Addendum No. 03

June 9, 2026

Parlier HS Stadium Replacement

PBK PROJECT NO.: 250093
DSA FILE NO.: 10-H12
DSA APPLICATION NO.: 02-124002 _ PARLIER HS STADIUM REPLACEMENT

Sheets C1 through C4 – Sewer and Storm Drain Plan and Profile

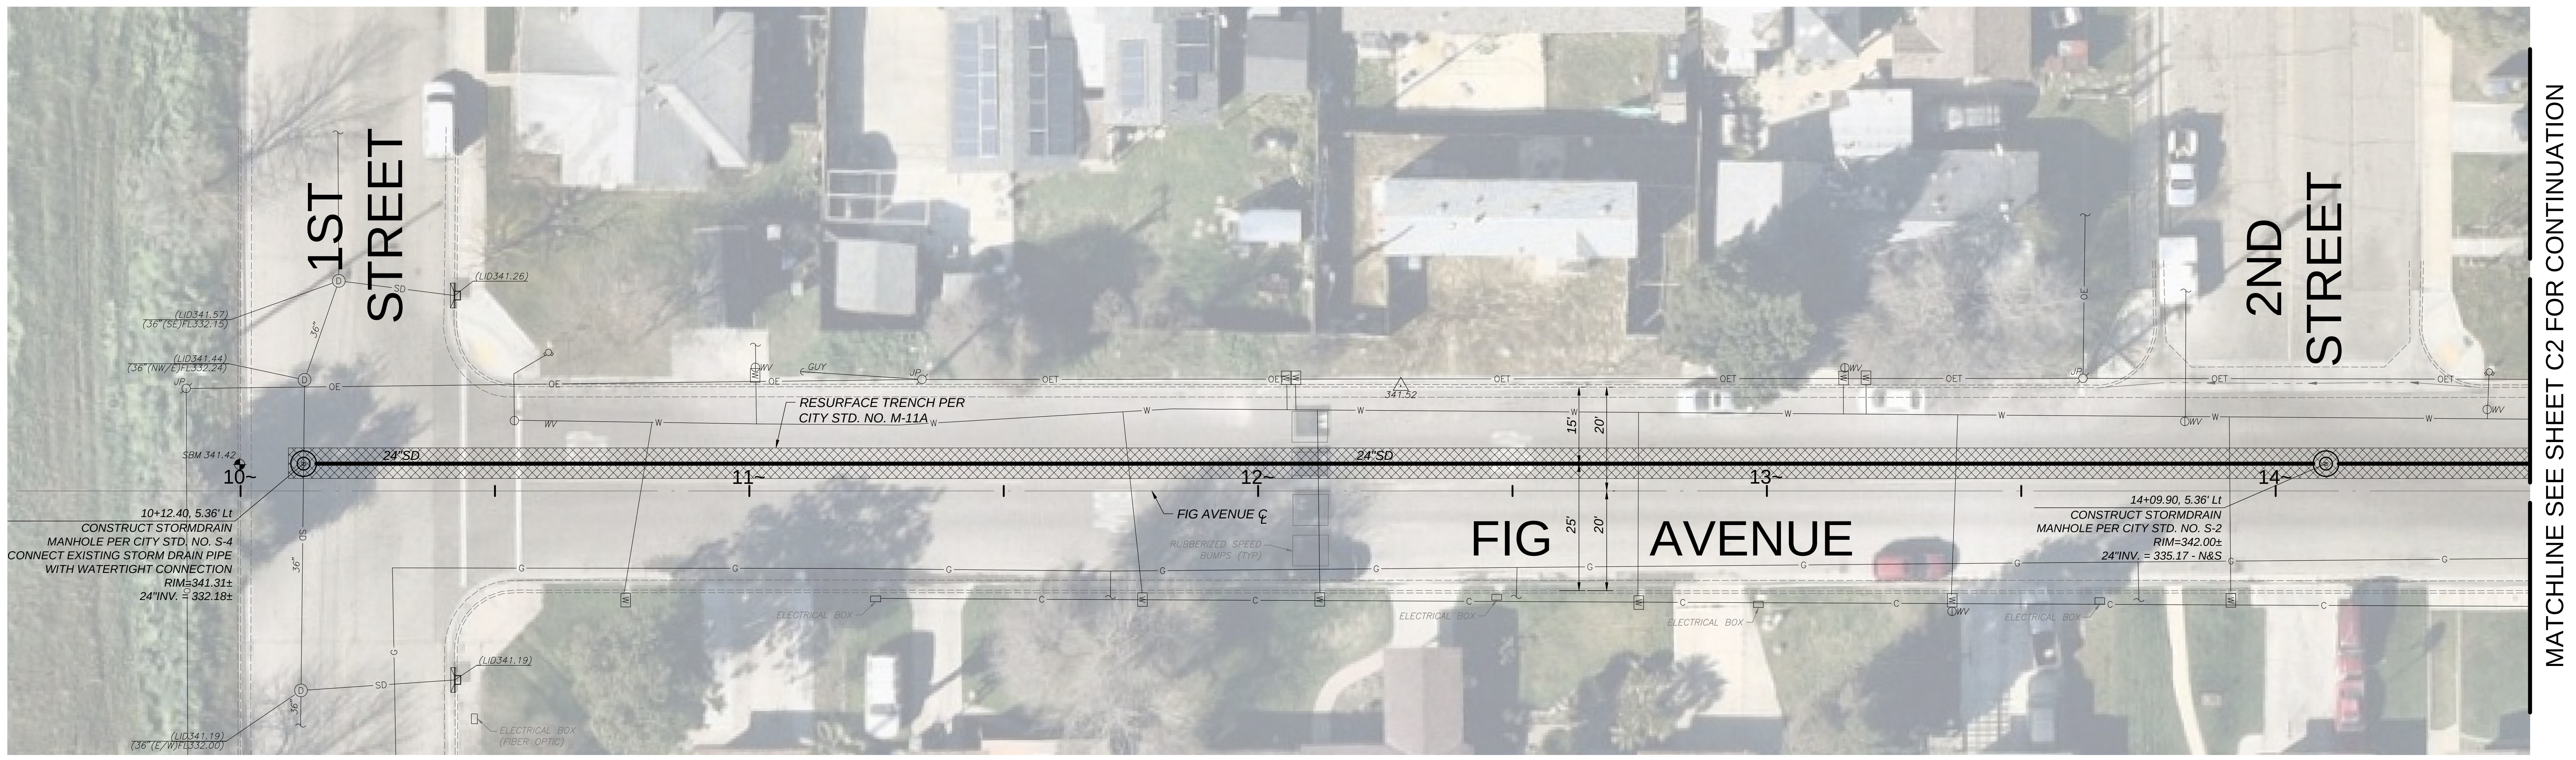
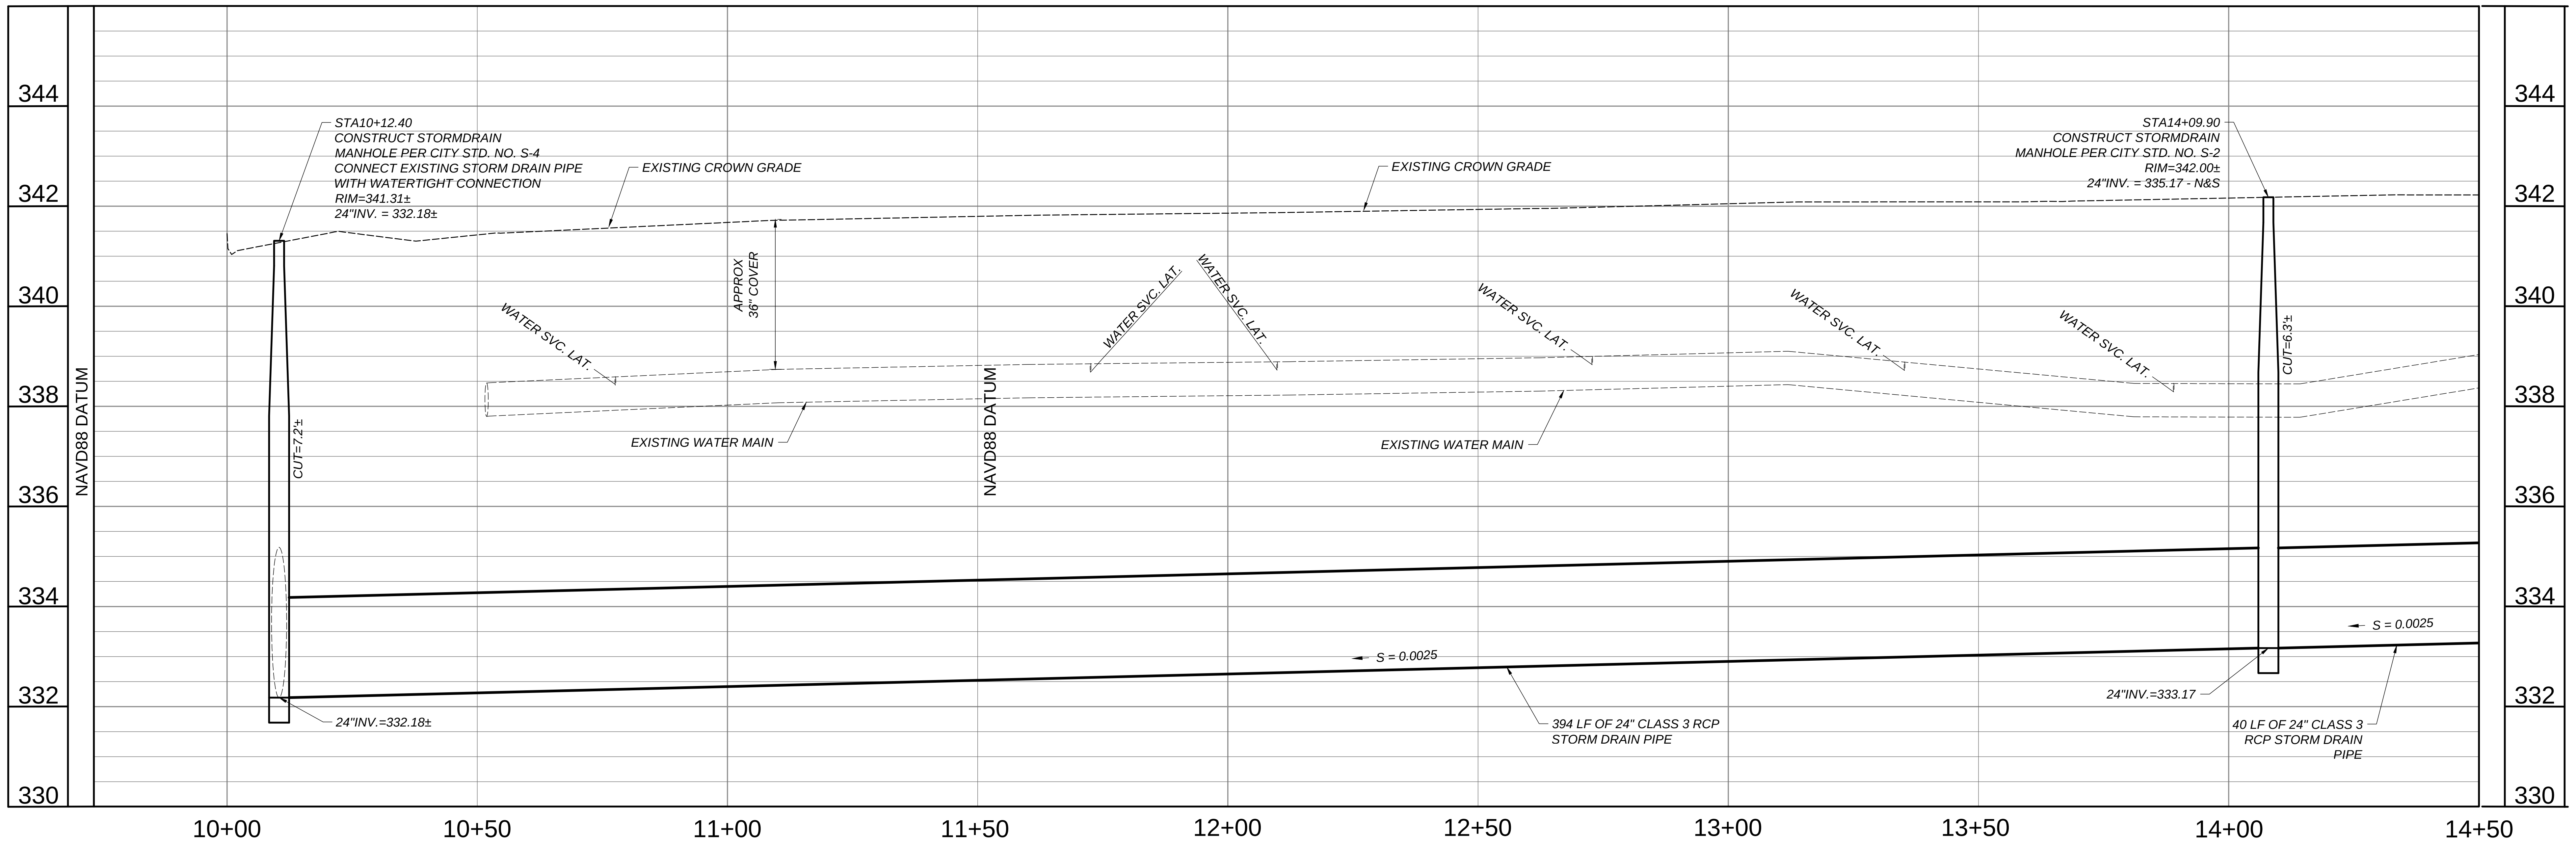
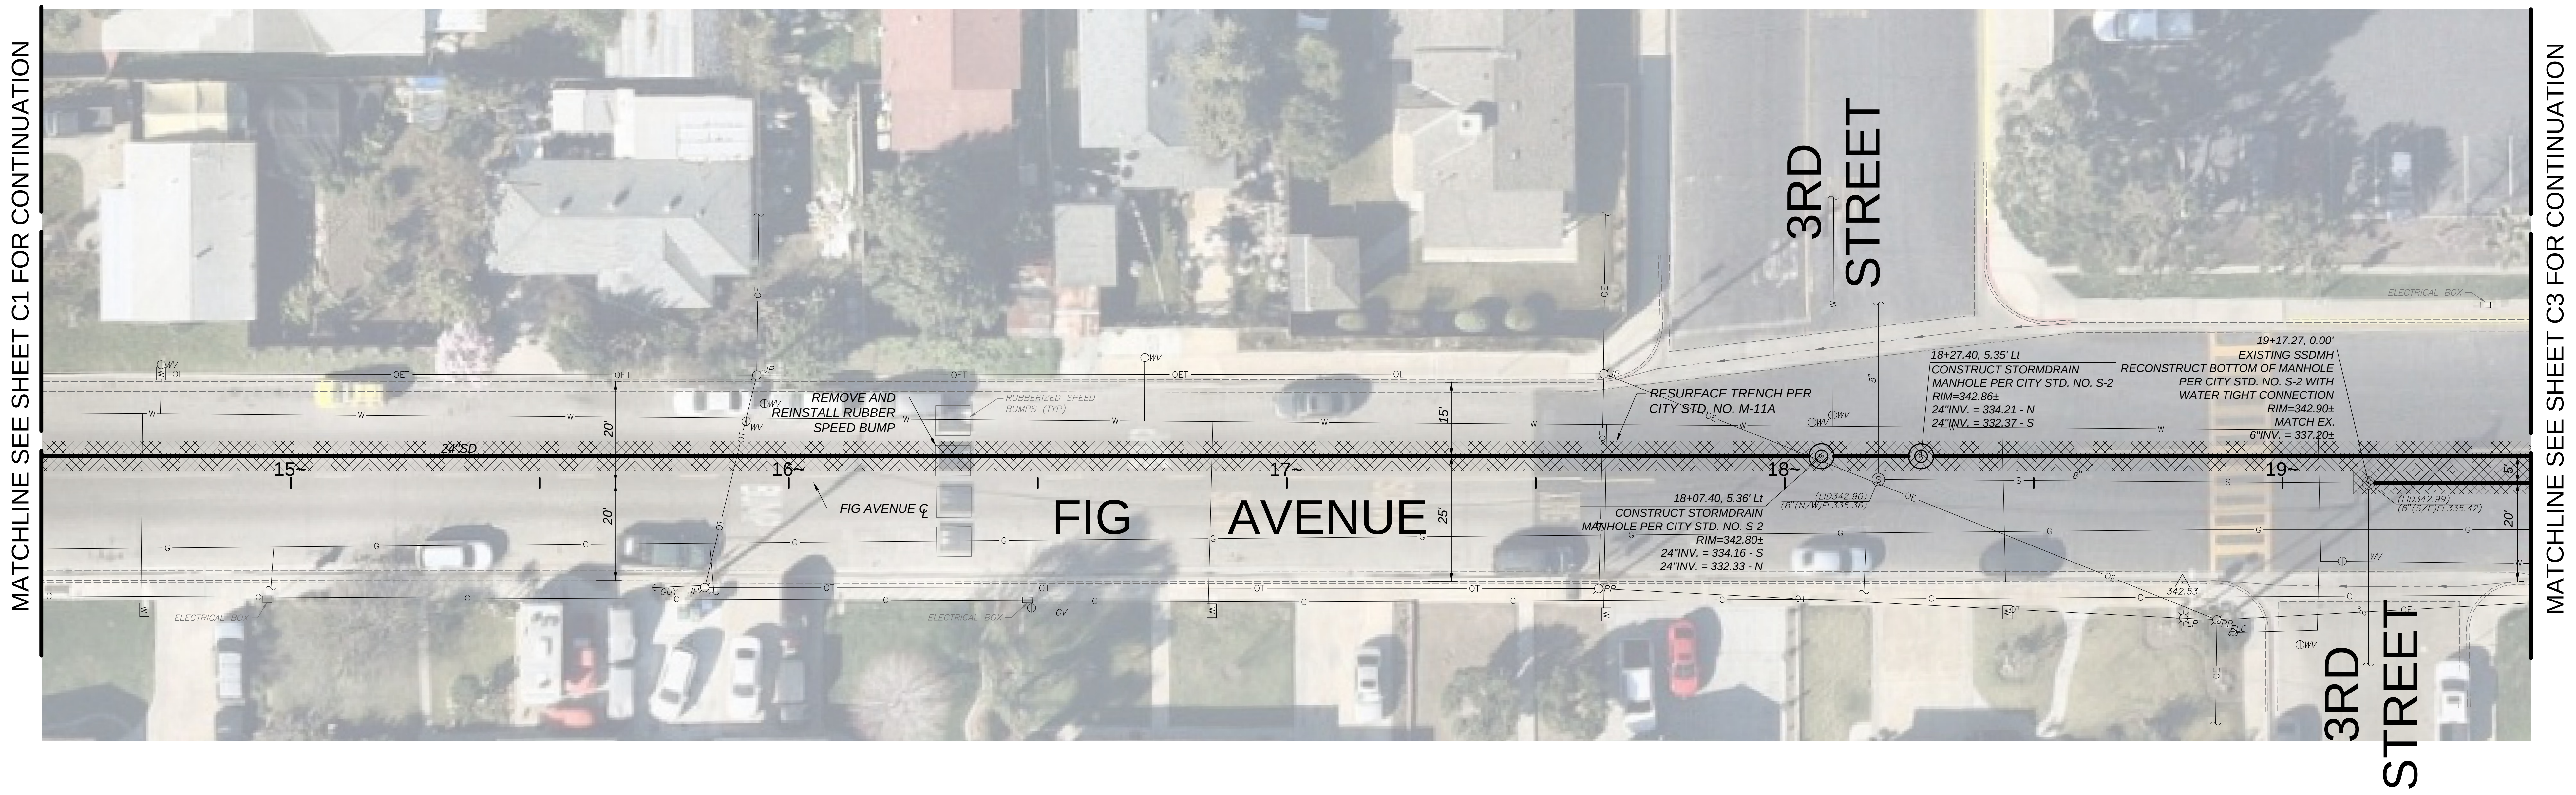
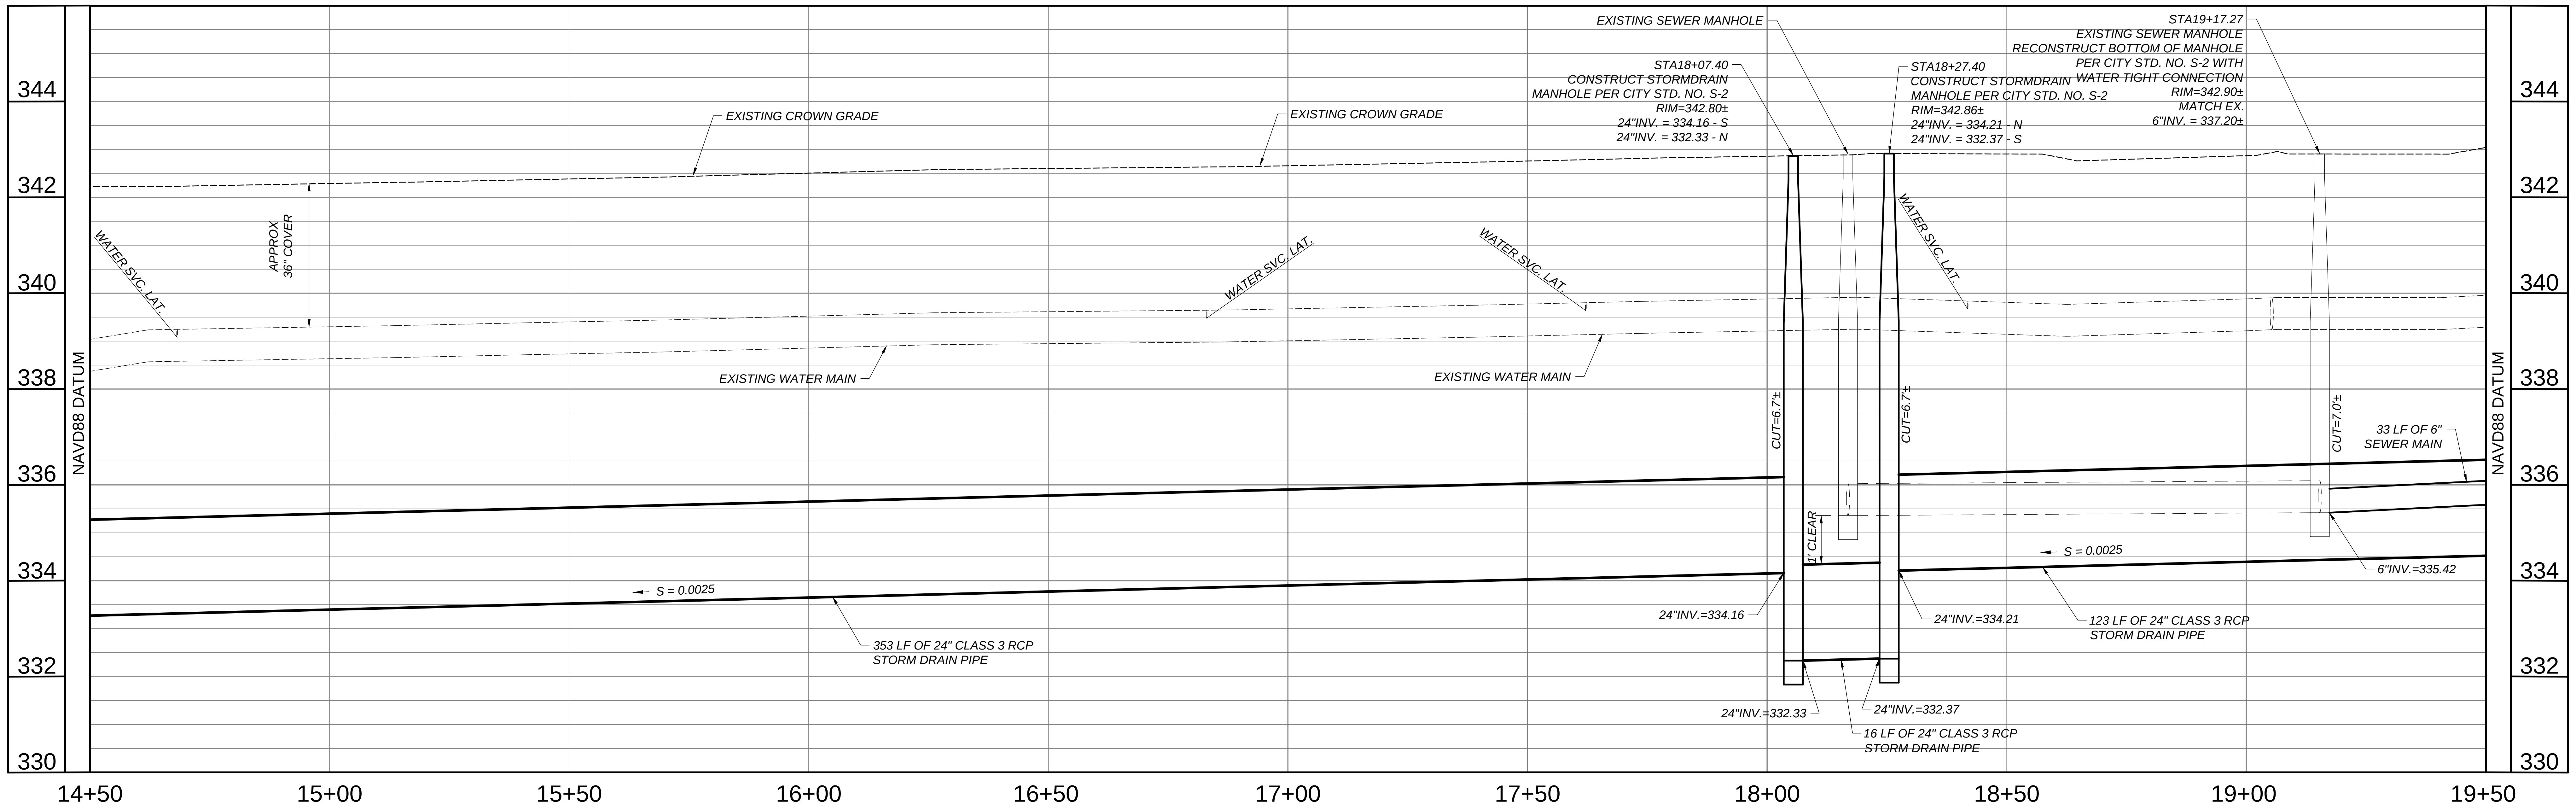
10. Refer to herein attached sheets C1-C4 “SEWER AND STORM DRAIN PLAN AND PROFILE”, identitified with AD3 on the bottom right-hand corner.
    a. Add attached sheets to the end of Sheet Section “CIVIL: SITE DEVELOPMENT.”

- Added plan and profile off site plans for sewer and storm drain.
